PCN-20210114 TE0600-03 DDR3 Change and Product Update

Company	Trenz Electronic GmbH
PCN Number	PCN-20210114
Title	TE0600-03 DDR3 Change and Product Update
Subject	BOM change
Issue Date	2021-01-25

Locate DDR3 RAM (U6, U7) on top side of PCB:

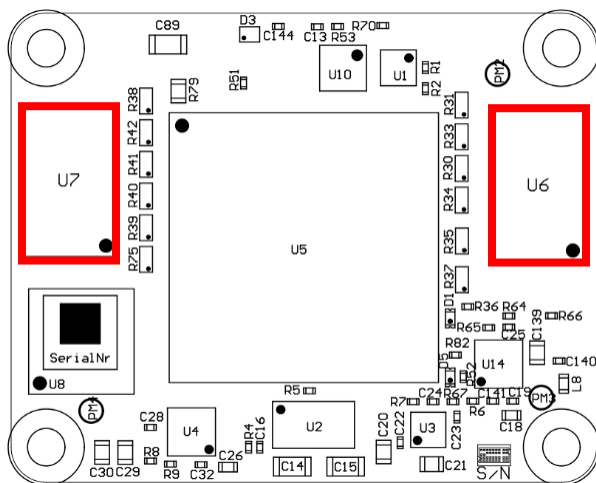
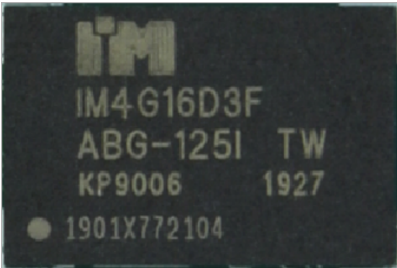
#1 Change DDR3 RAM from IM4G16D3FABG-125I to IS43TR16256BL-125KBLI

Type: BOM change

Reason: Component is end of life.

Impact: New DDR timings may be considered in designs.

old	new
IM4G16D3FABG-125I	IS43TR16256BL-125KBLI
